# **FUNCTIONAL SERVICING REPORT**

## **TAMARACK (RICHMOND EAST) CORPORATION LANDS**

**OCTOBER 6<sup>TH</sup>, 2025  
3<sup>RD</sup> SUBMISSION  
© DSEL**

Tamarack Response to 2nd Submission City Comments dated December , 2025 (Feedback Form - 2nd Submission - 6038, 6012, 5970 Ottawa Street)		
File Number: D07-16-20-0028		
No.	Comment	Response
<b>Planning (Sarah McCormick)</b>		
List of Studies and Plans Reviewed:

<p>120 IBER ROAD, UNIT 103 SUITSVILLE, ONTARIO, K2S 1E9 Tel: (613) 836-8856 Fax: (613) 836-7183 www.DSEL.ca</p>	TAMARACK RICHMOND	GRADING PLAN	
	CITY OF OTTAWA	SCALE: 1:2000	PROJECT No.: 1042
		DATE: SEPTEMBER 2025	DRAWING: 04D

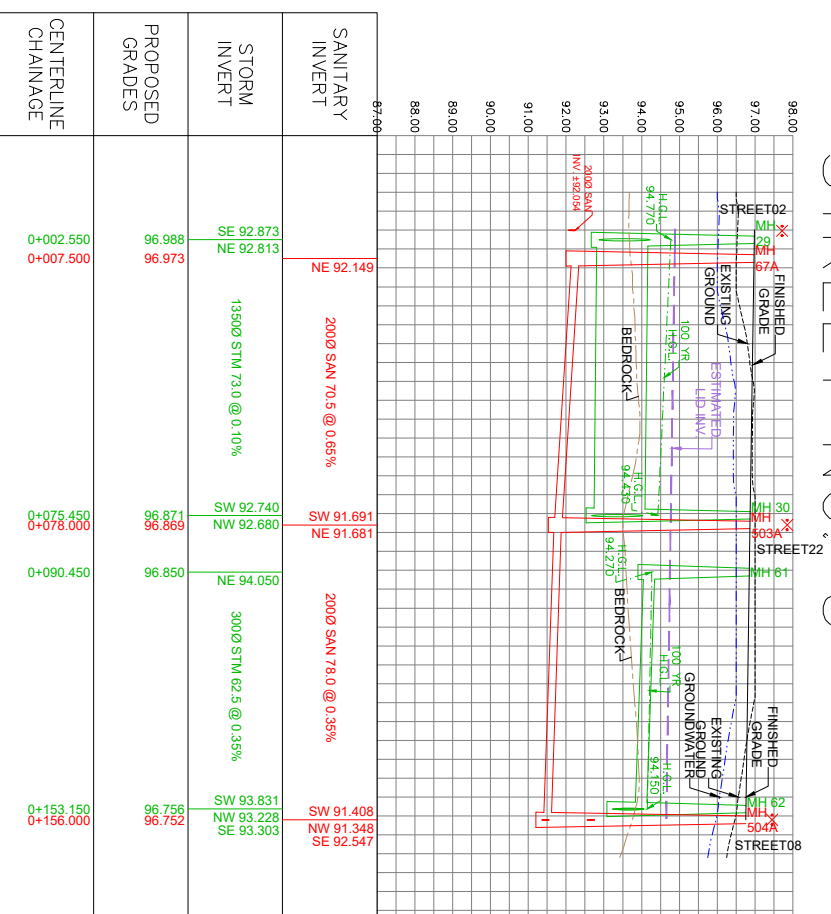
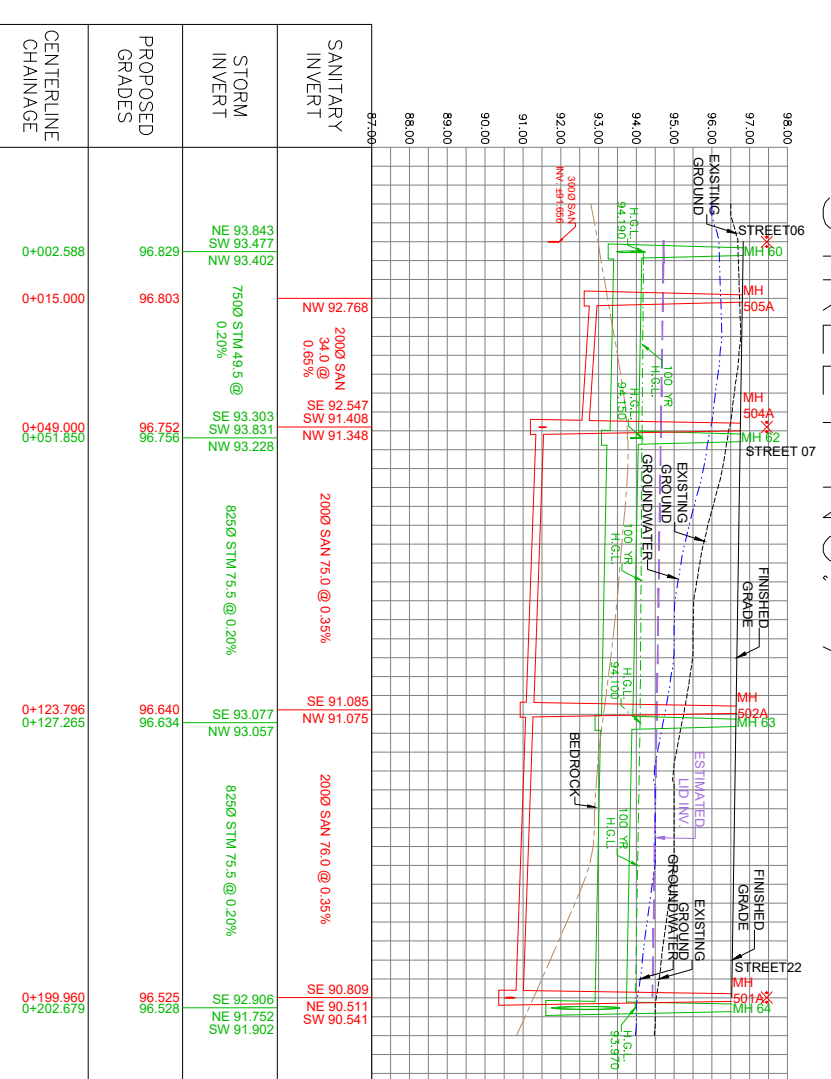
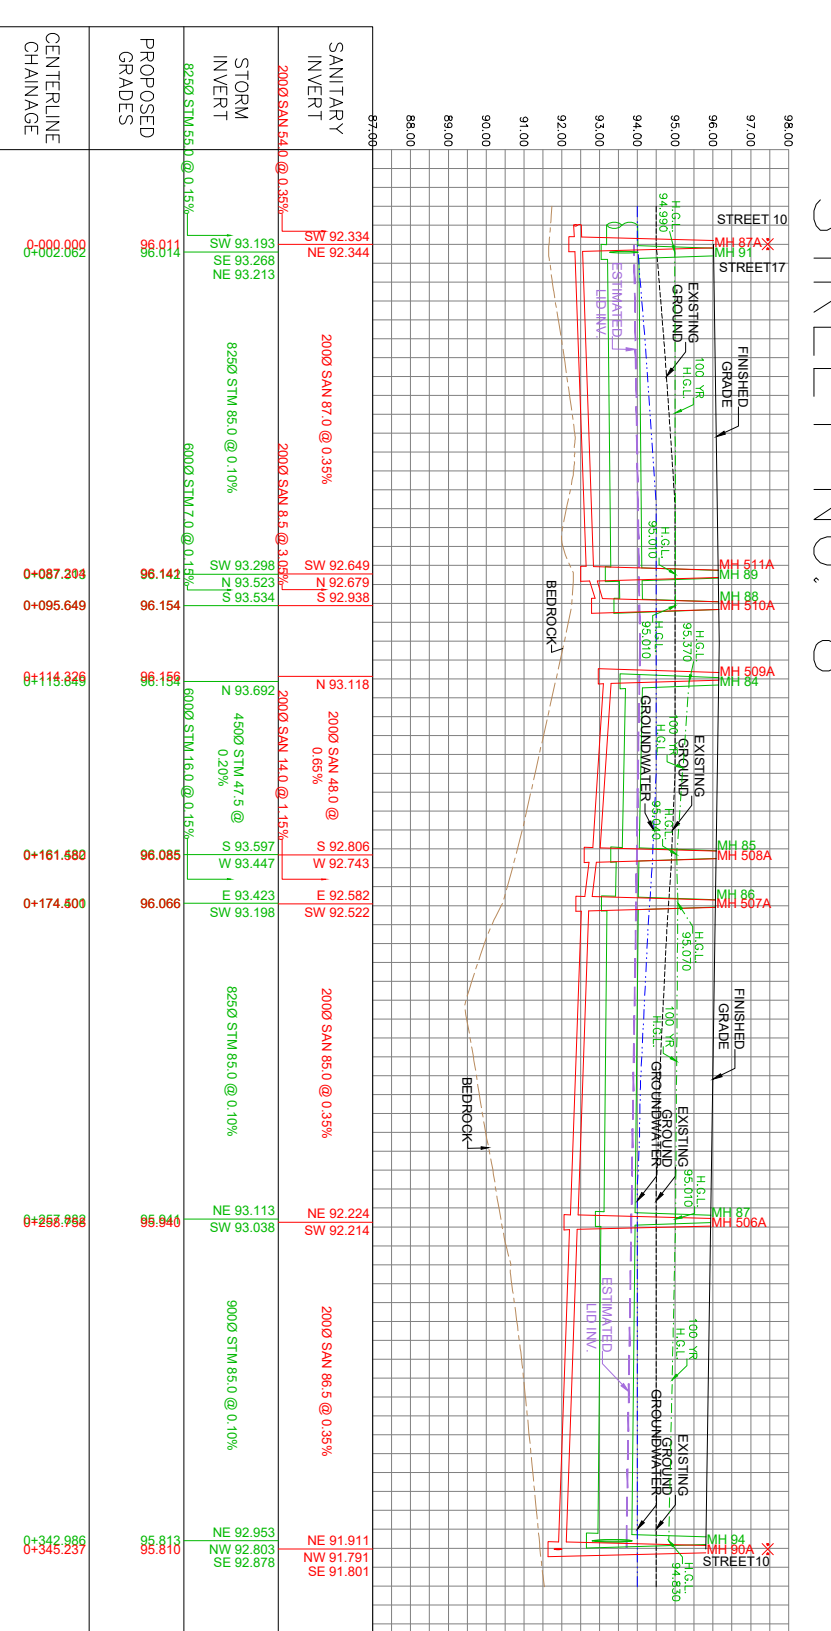
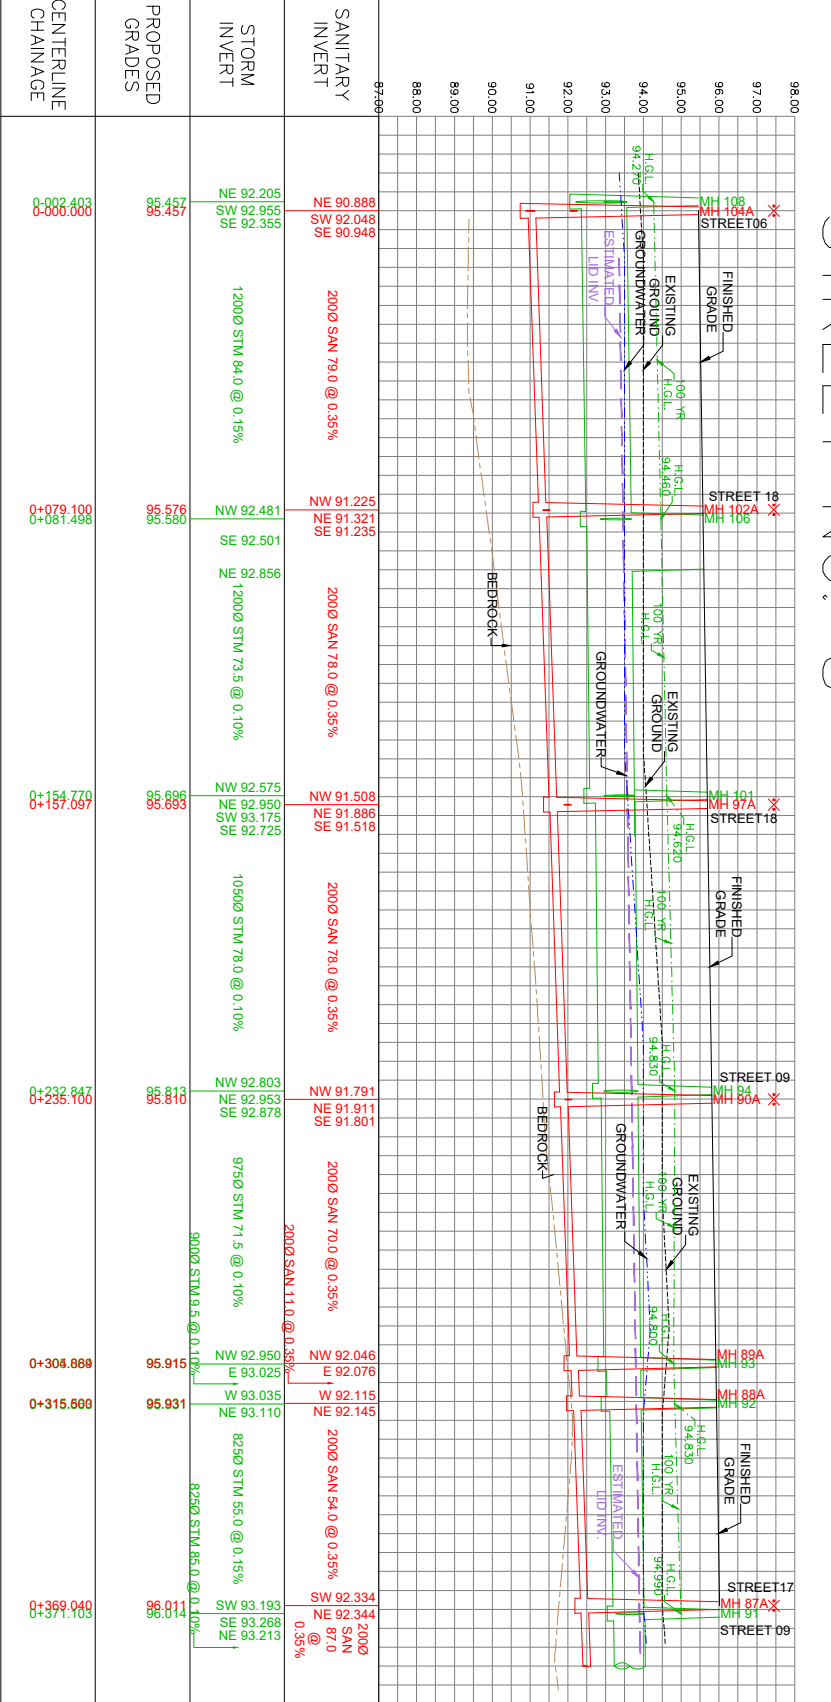
Preliminary Comments:		
72	It appears the plan shows a grade raise beyond that permitted- please provide grade raise calculations.	Exceedances of grade raise restrictions in the revised grading are summarized in Drawing 08D. As part of the detailed design, these exceedances will be coordinated with Paterson Group and managed via the use of lightweight fill or a settlement surcharge program.
73	The datums used to establish the horizontal and vertical datums for the survey need to be shown on at least one of the grading plans.	The datums have been added to the Grading Plan (Drawing 04D) as requested..

123	The Grading Plan, prepared by DSEL, drawing no. 1042-04D, dated March 2025, should have existing grading information.	Existing ground grading contours are included in the Grading Plan (Drawing 04D).
124	The proposed grading plan shows grade raises beyond the limit of the Geotechnical Report, please provide the actual grade raise calculations	See <b>Comment #72</b> .
125	As per the CLI ECA process please provide a segmented Environmental Risk Assessment for the sediment and erosion control	Please elaborate on this requirement, specifically, the location where this is detailed as a requirement in the CLI-ECA agreement. If required, it can be prepared as part of the detailed design process.
126	As per the CLI ECA process, following the Erosion and Sediment Control Guidelines for Urban Construction (2019), please provide a RUSLE equation per Appendix A of the CLI ECA agreement between the City and MECP. a. This proposed development needs to target for control the stormwater volumes generated from the 90th percentile rainfall event. b. Control must be in the following hierarchical order, with each step exhausted before proceeding to the next: 1) retention (infiltration, reuse, or evapotranspiration), 2) LID filtration, and 3) conventional Stormwater management. Step 3, conventional Stormwater management, should proceed only once Maximum Extent Possible has been attained for Steps 1 and 2 for retention and filtration. If conventional methods are necessary then enhanced, normal, or basic levels of protection (80%, 70%, or 60% respectively) for suspended solids removal are required based on the receiver- (in this case 80 %). c. A treatment train approach is needed	A RUSLE is not a requirement of the CLI-ECA agreement. Per Appendix A of the CLI-ECA agreement, the ESC plan shall "Have regard to Erosion and Sediment Control Guideline for Urban Construction 2019 by TRCA (as amended)". Regardless, requirements for the CLI-ECA will be provided as part of the detailed design.  All rainfall events, either through the minor/major system, are directed to the proposed SWM pond, exceeding the 90th percentile volumes. As detailed in <b>Comment #122</b> , infiltration-type LIDs are not considered viable for the site, and other opportunities for retention upstream of the proposed SWM pond, though not required for erosion or quantity control, will be explored as part of the detailed design process.

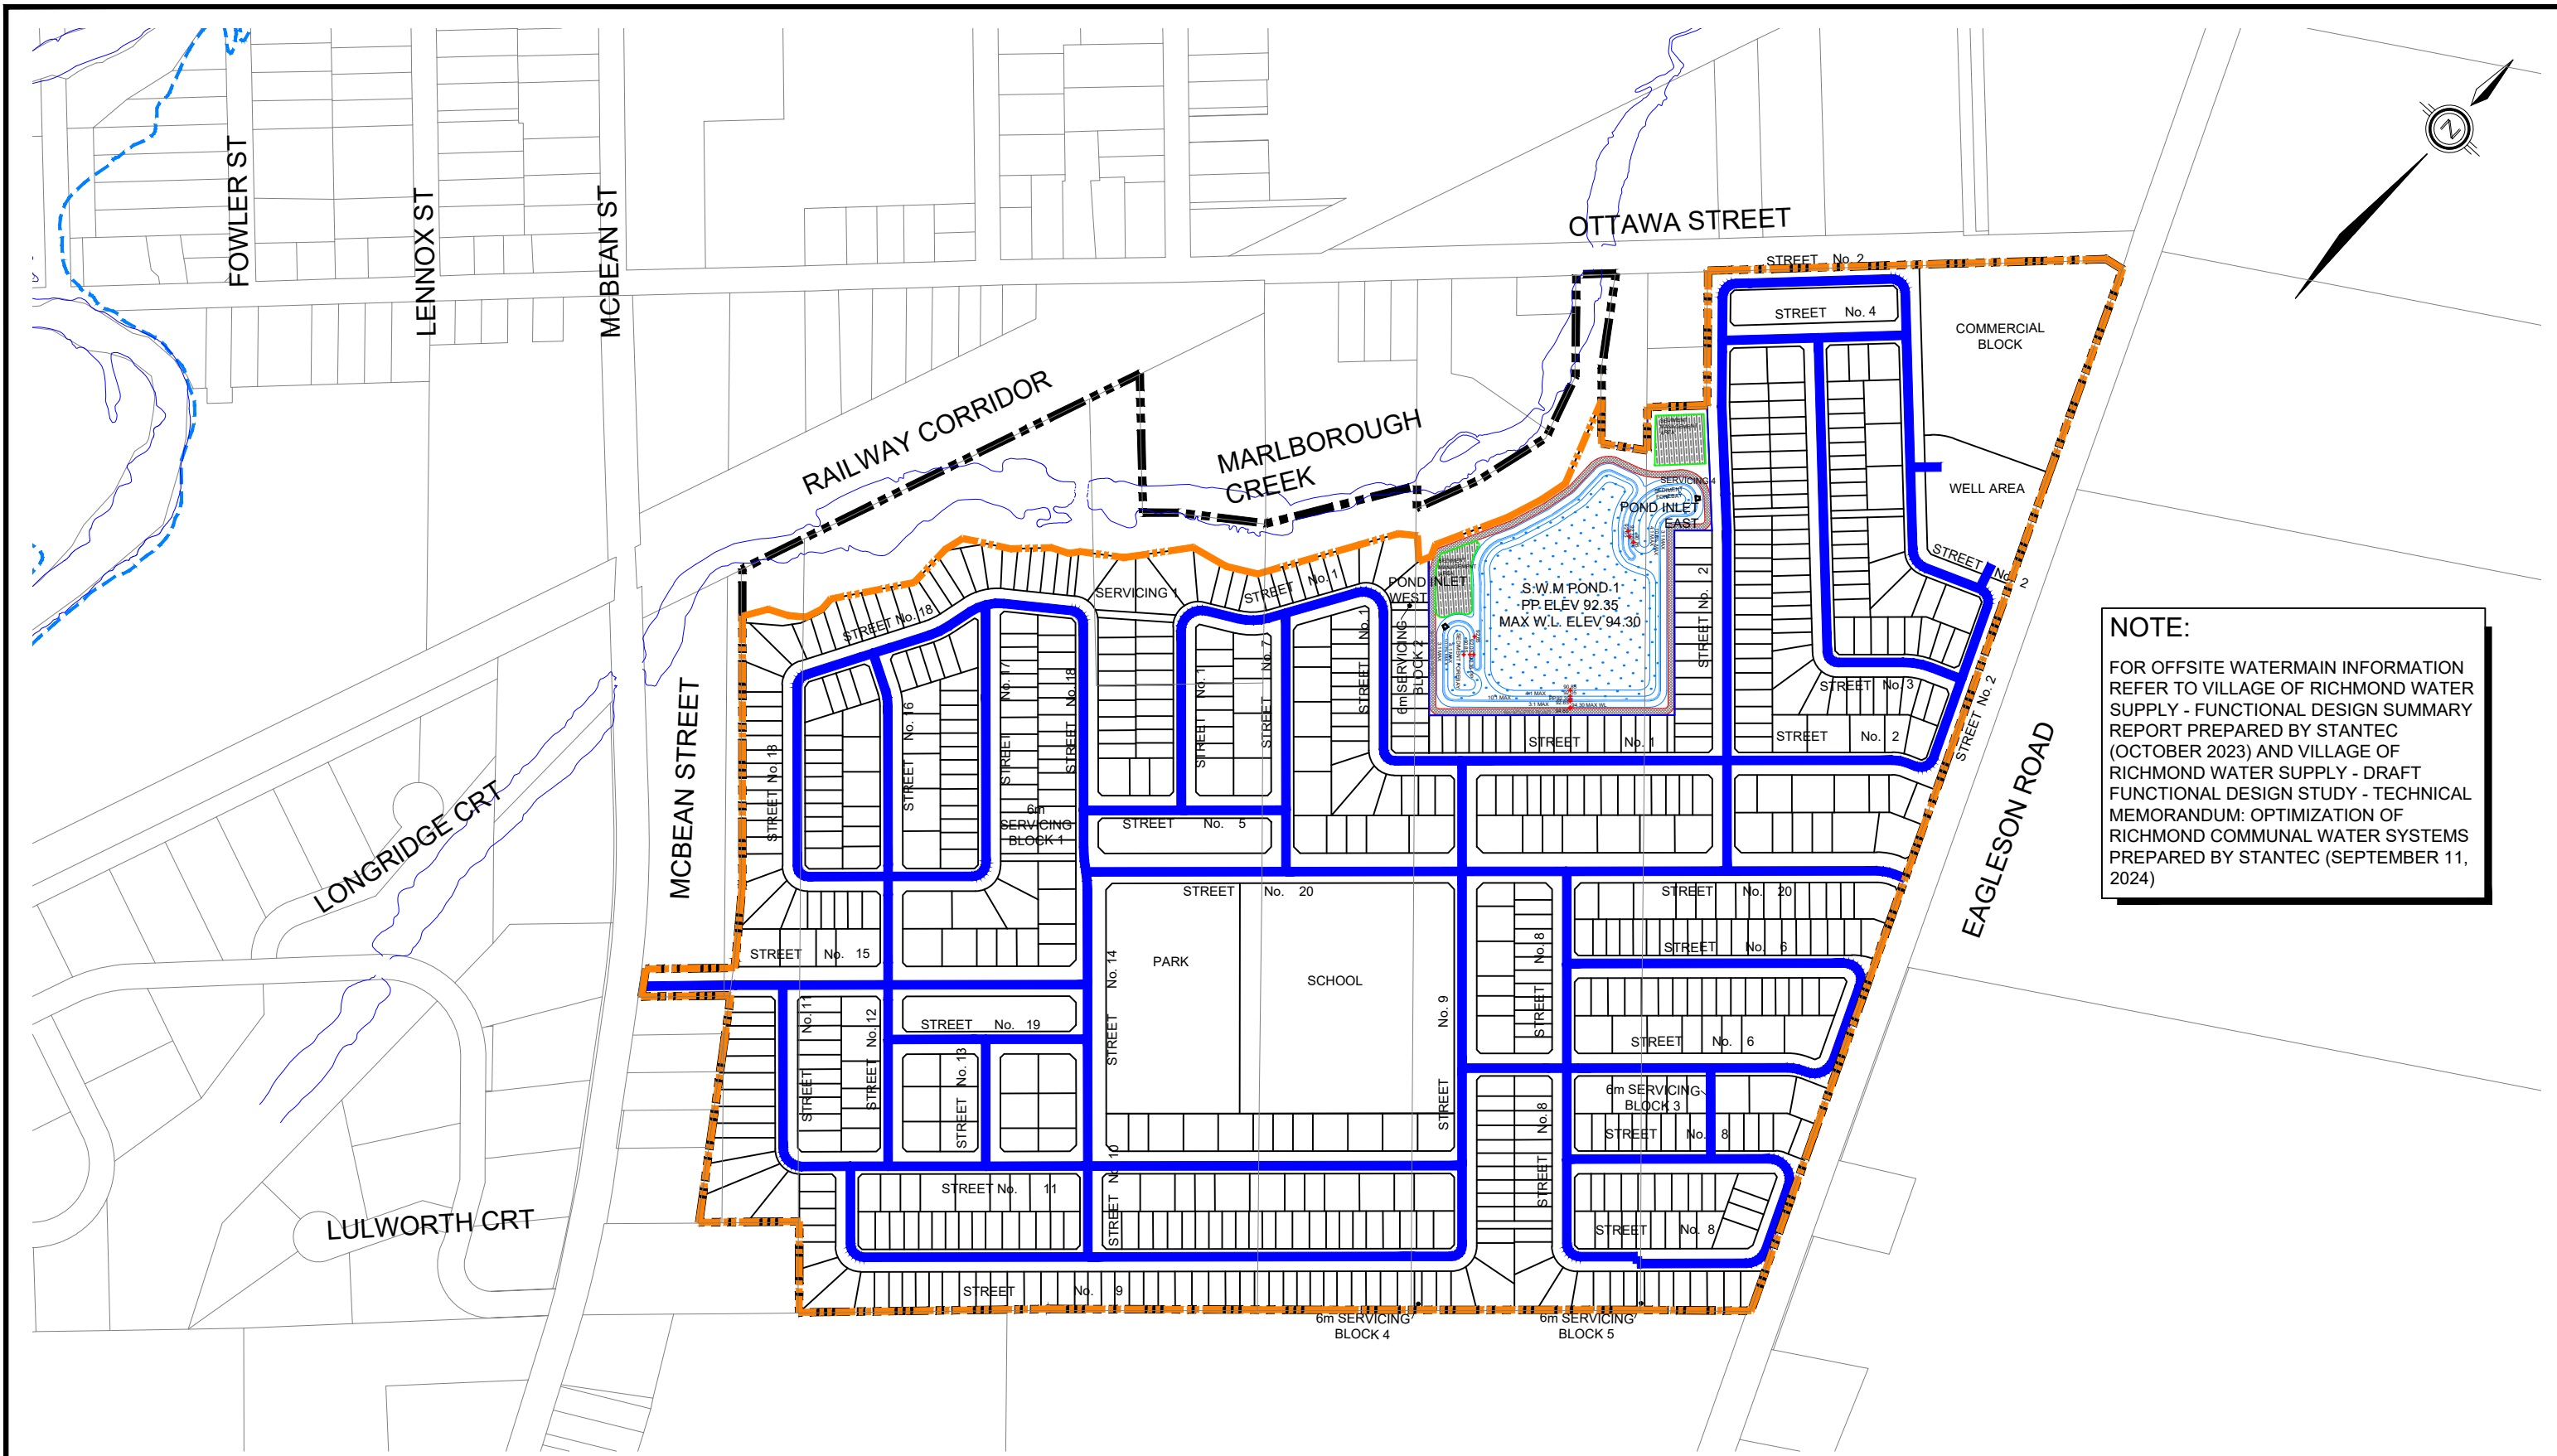
Erosion and Sediment Control Plan, 03F, prepared by prepared by DSEL, dated November 2020.		
Preliminary Comments:		
74	The plan shows an access at a location that requires ownership and the ownership has not been confirmed. The silt fence splits the site in two; please provide rationale for the split. Sediment traps are suggested to be replaced due to the presence of clay. In due course additional comments will be provided.	All site access locations are within the subject lands owned by the applicant. The silt fence shown to "split the site in two" is to protect Reach 4 until approvals are in place for it's removal.
Functional Servicing Report, Project No 18-1042, prepared by DSEL, dated March 20, 2025.		
106	The headwater drainage feature discussed in section 1.1, reach 4, does not appear to be carried to conclusion.	Discussion of the headwater features has been revised for clarity and added to the conclusion of the FSR (Section 8.0).
